STORIE LOU PLAZA JSP20-19

Matter of Consideration at the request of Alrig LLC for approval of the Preliminary Site Plan, Stormwater Management Plan, and Section 9 Façade Waiver. The subject property contains 1.41 acres and is located in Section 14, on the east side of Novi Road, north of Crowe Drive. The site is currently developed with a branch of the Fifth Third Bank. The applicant is proposing to redevelop the site into a 7,000 square foot multi-tenant building that proposes one retail tenant and one restaurant.

PLANNING REVIEW

PLAN REVIEW CENTER REPORT

DRAWING: **C-3**

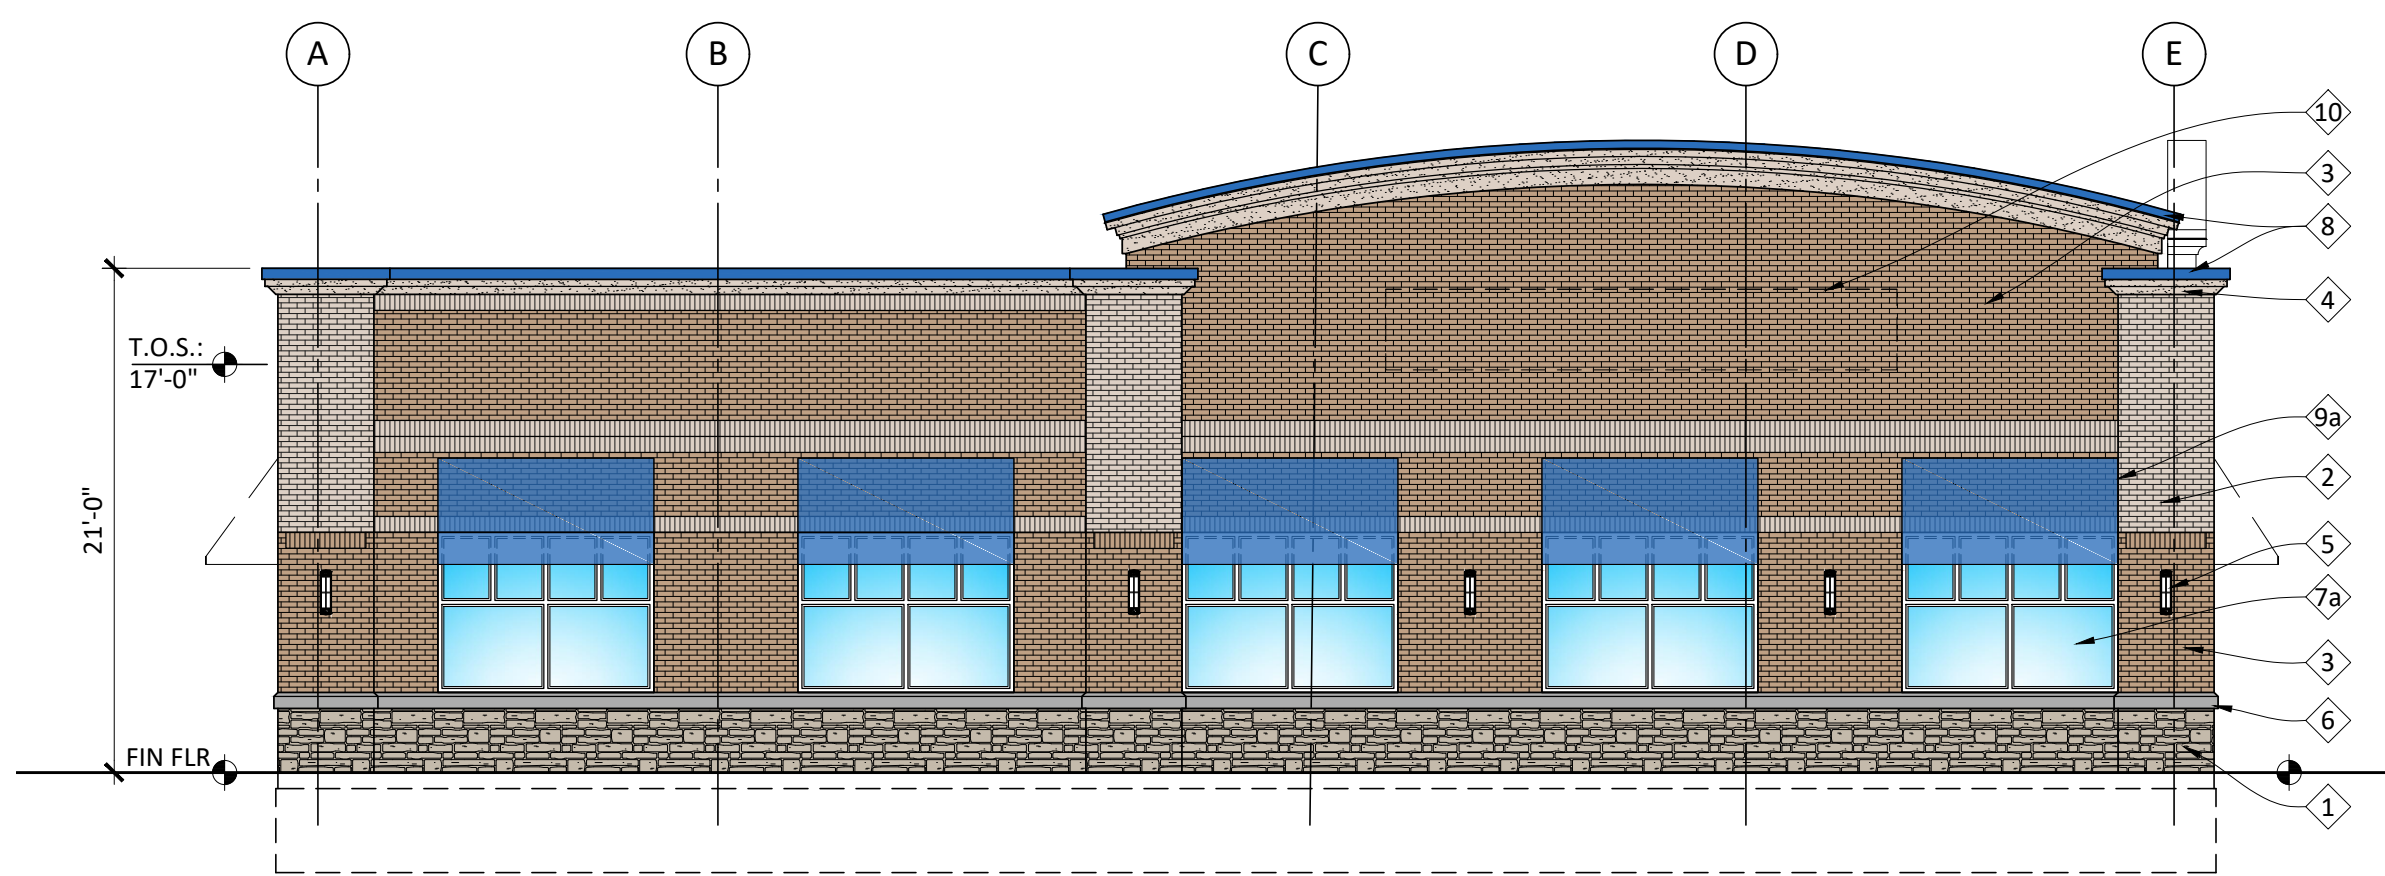
SIGNING AND STRIPING				
No.	Item	Proposed	Compliance	Remarks
32	Signing: Sizes MMUTCD	Included	Met	
33	Signing table: quantities and sizes	Partial	Not met	ADA signs should be included in the 'Sign Data Table' on sheet C-3.
34	Signs 12" x 18" or smaller in size shall be mounted on a galvanized 2 lb. U-channel post MMUTCD	Included	Met	
35	Signs greater than 12" x 18" shall be mounted on a galvanized 3 lb. or greater U-channel post MMUTCD	Included	Met	
36	Sign bottom height of 7' from final grade MMUTCD	Included	Met	
37	Signing shall be placed 2' from the face of the curb or edge of the nearest sidewalk to the near edge of the sign MMUTCD	Included	Met	
38	FHWA Standard Alphabet series used for all sign language MMUTCD	Included	Met	
39	High-Intensity Prismatic (HIP) sheeting to meet FHWA retro-reflectivity MMUTCD	Included	Met	
40	Parking space striping notes	Included	Met	
41	The international symbol for accessibility pavement markings ADA	Included	Met

39. *Signing table; quantities and sizes- ADA signs should be included in the 'Sign Data Table' on sheet C-3.*

ADA sign date table will be added to sheet C-3

SOUTH ELEVATION
 SCALE: 1/8" = 1'-0"
 AWNING PERCENTAGE: 10%

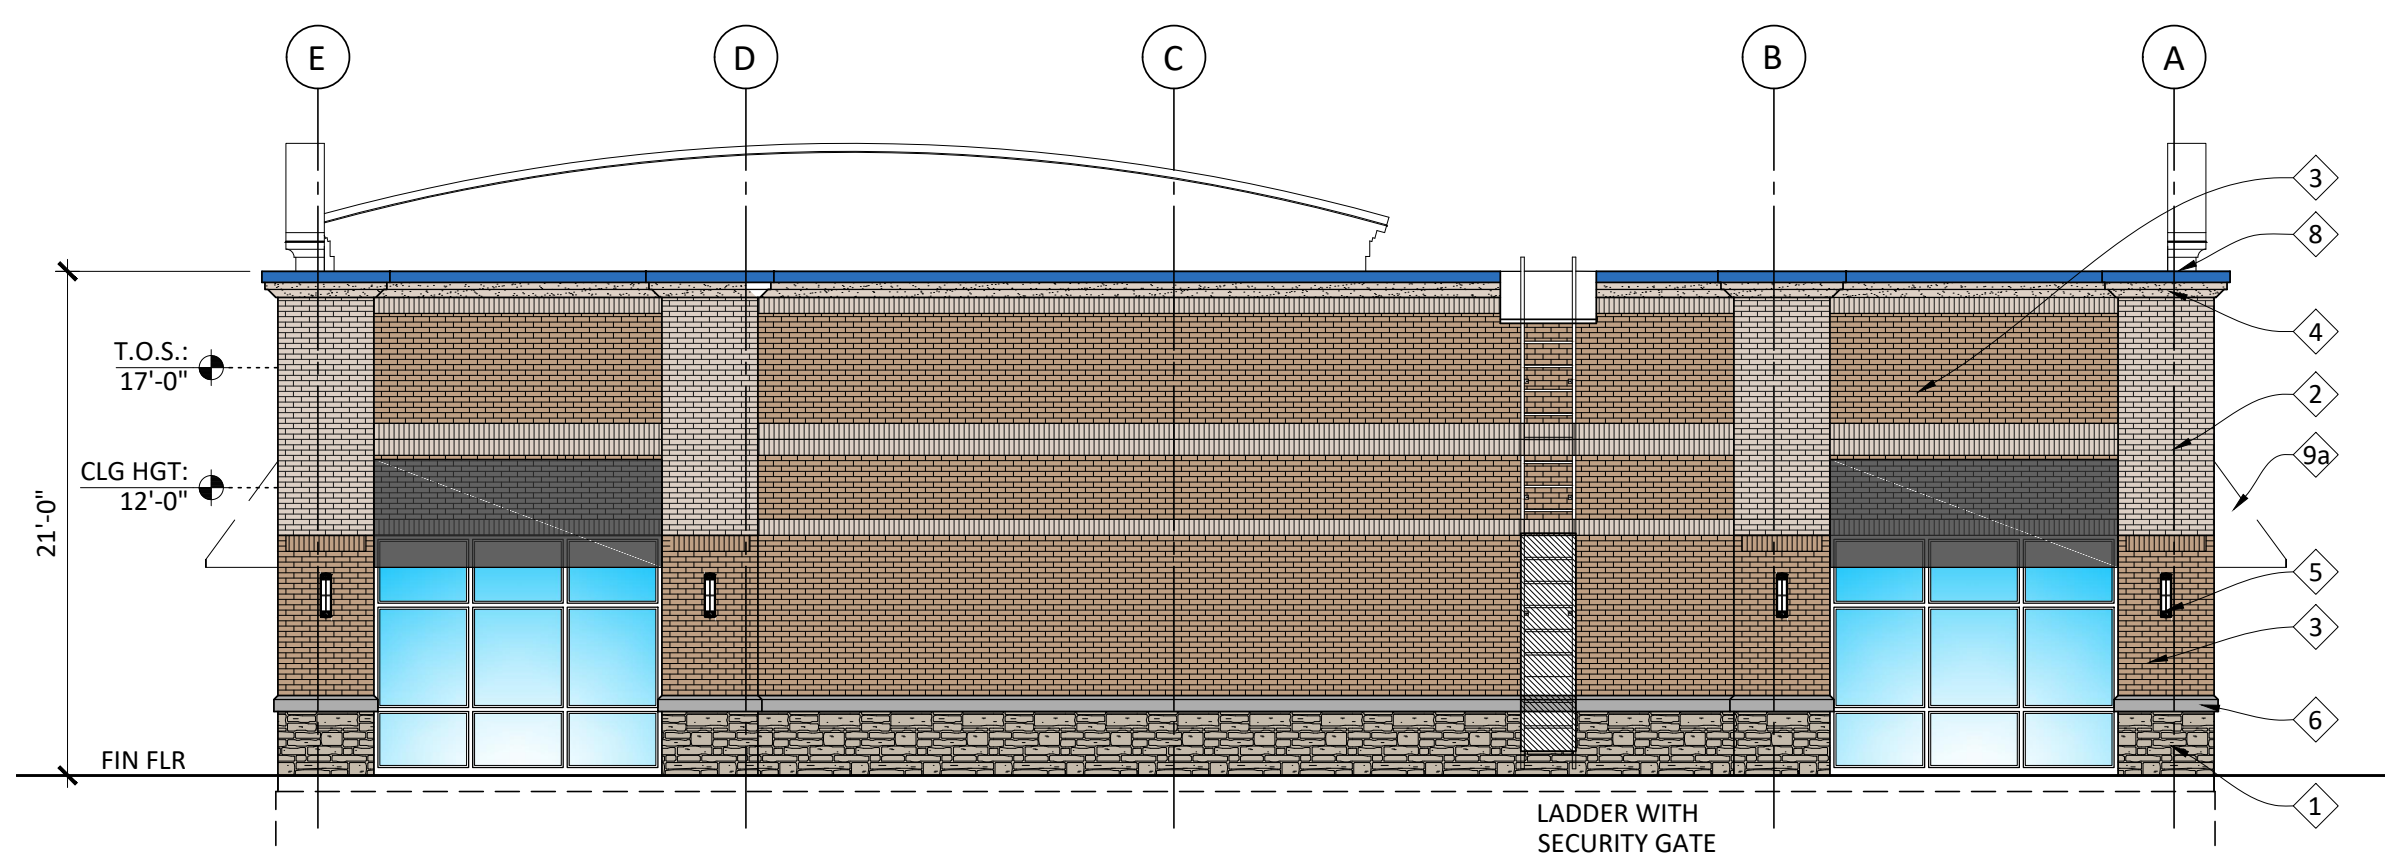
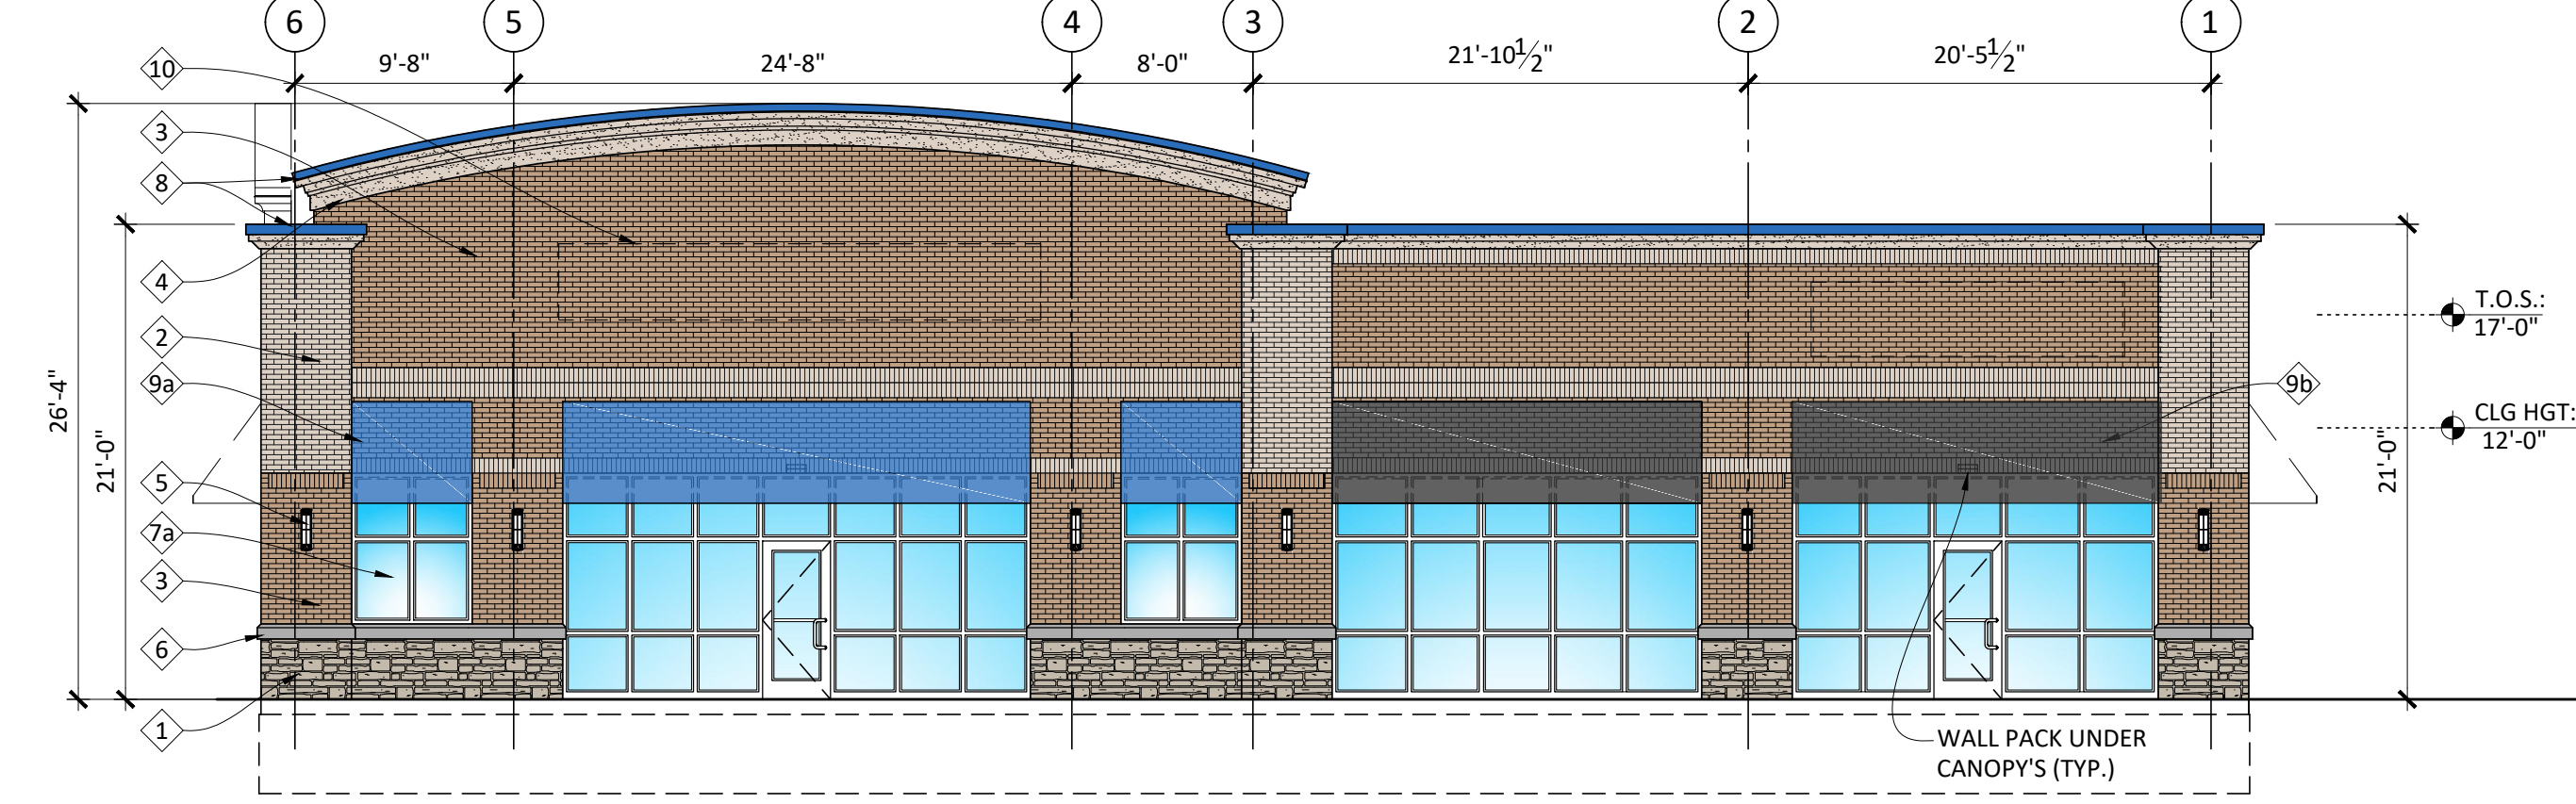
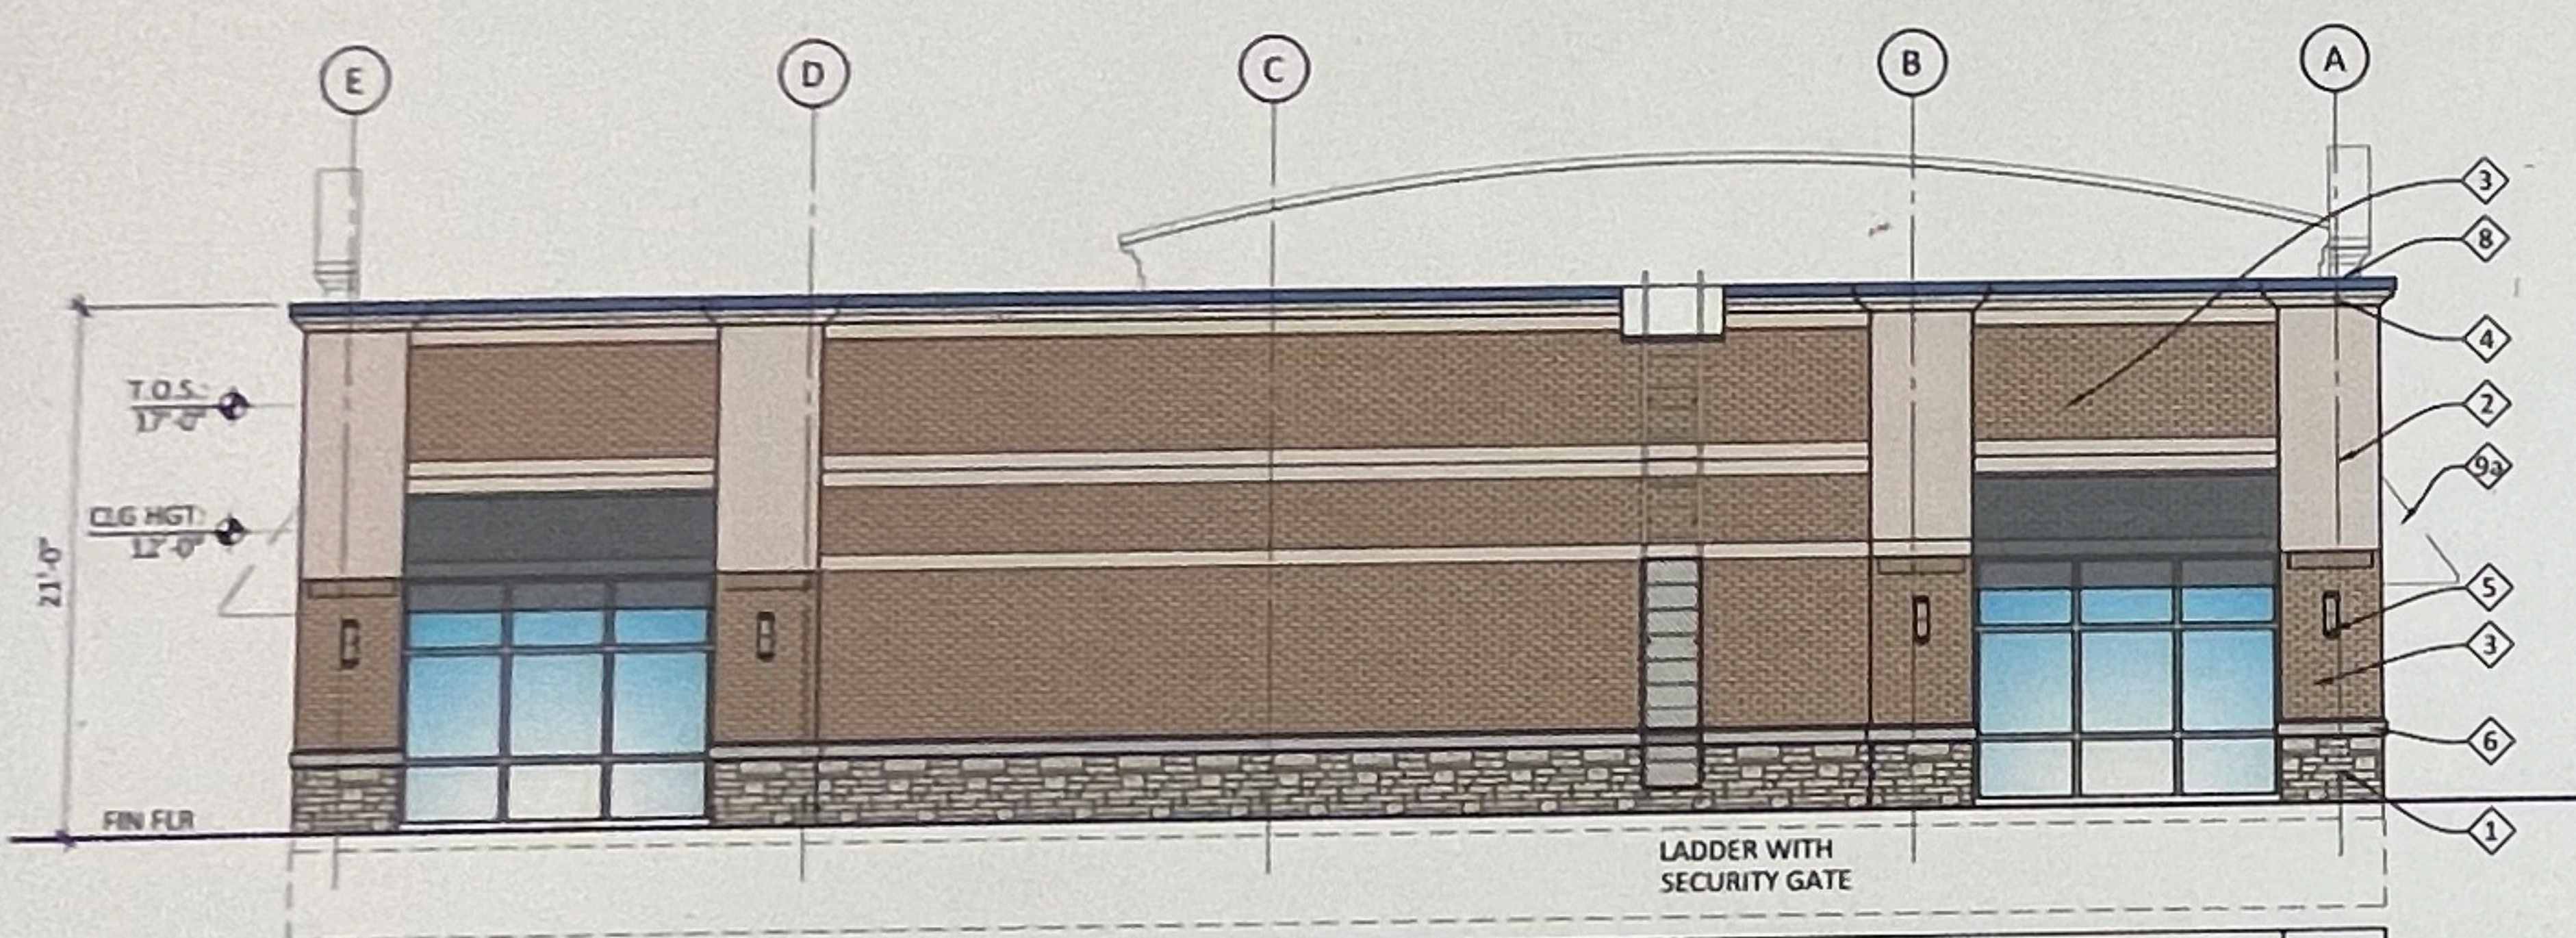
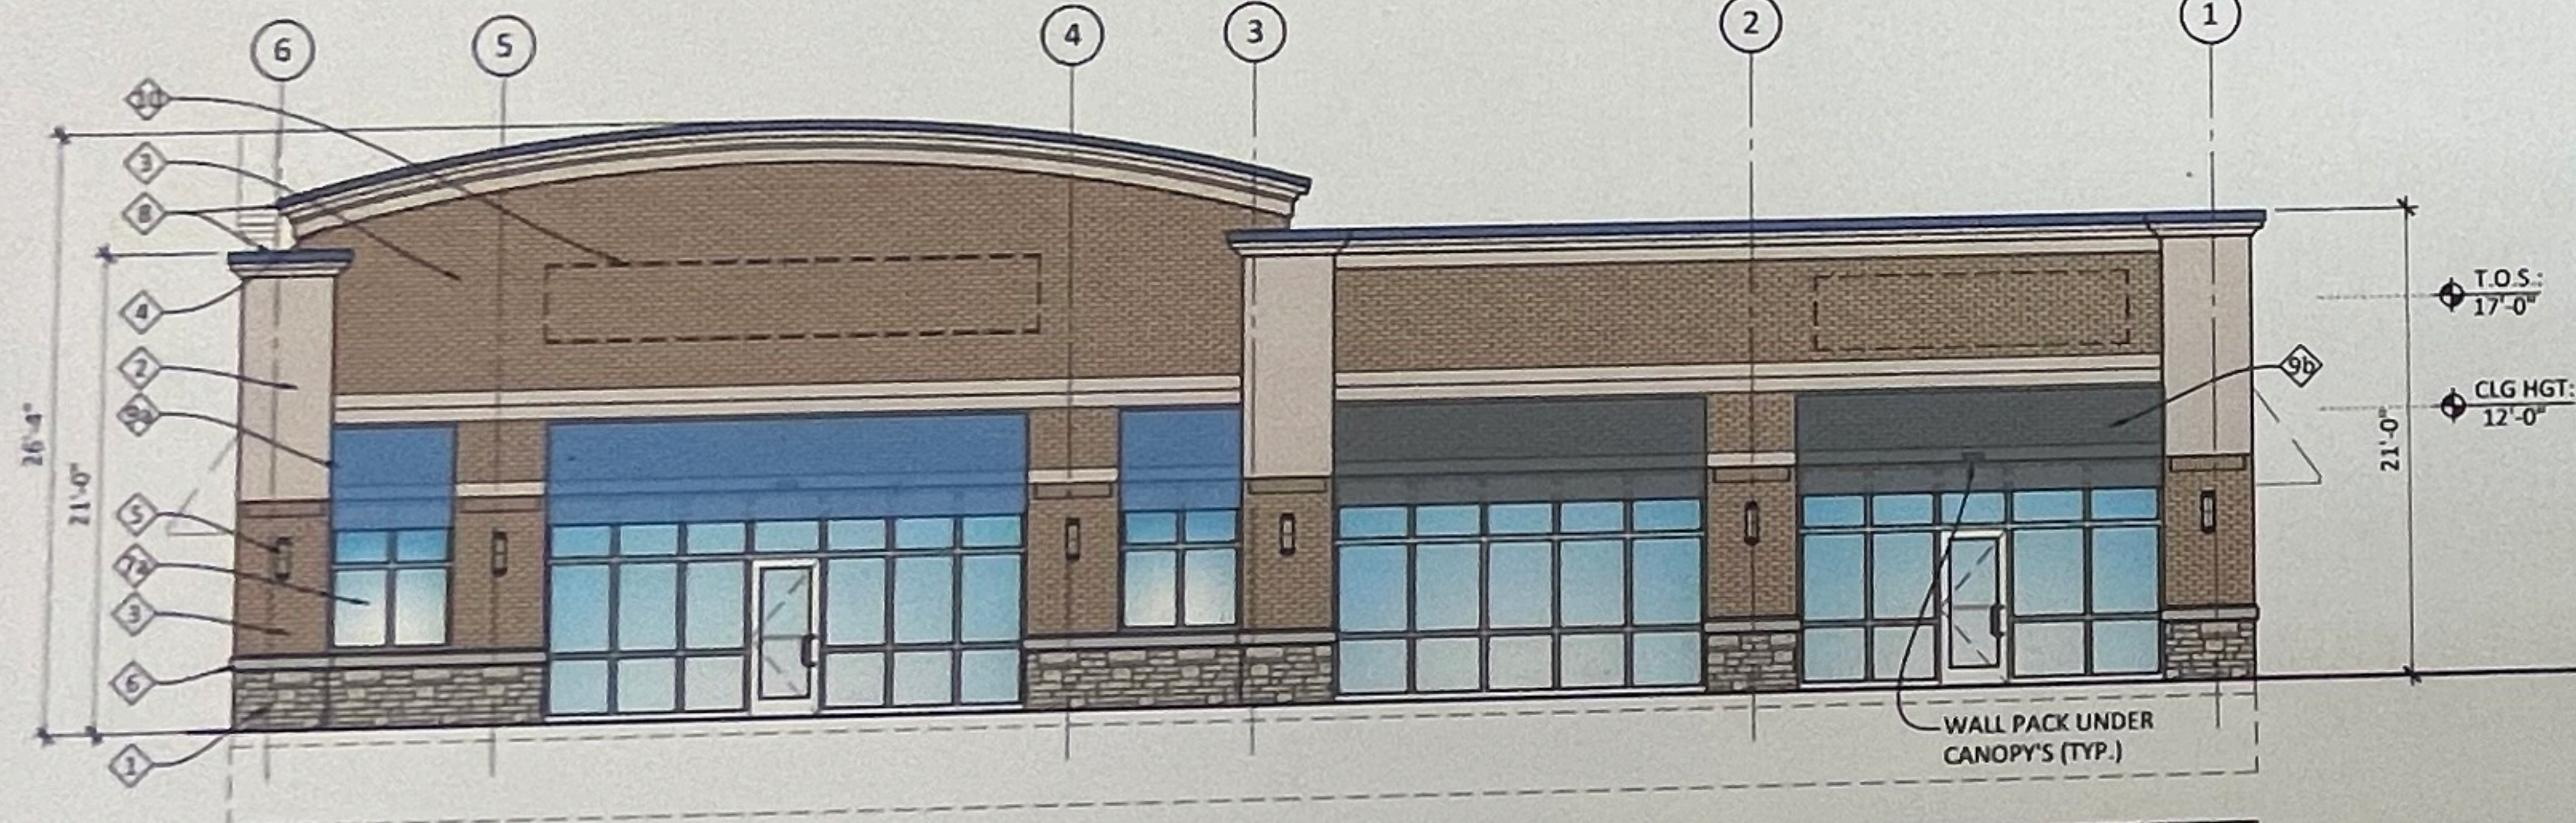
Façade	Approval recommended	10-13-20	<ul style="list-style-type: none"> A Section 9 Façade Waiver is required as the percentage of fabric awning exceeds the maximum percentage allowed (supported by the façade consultant because the proposed materials are consistent with the surrounding area)
Fire	Approval recommended	10-13-20	<ul style="list-style-type: none"> Items to be addressed on the Final Site Plan Submittal

- c. Section 9 Façade Waiver for an overage of fabric awning on the west (10% allowed, 14% proposed), east (10% allowed, 19% proposed), and south (10% allowed, 14% proposed) elevations *because the proposed design does not adversely affect the aesthetic quality and meets the intent and purpose of the Ordinance, which is hereby granted;*
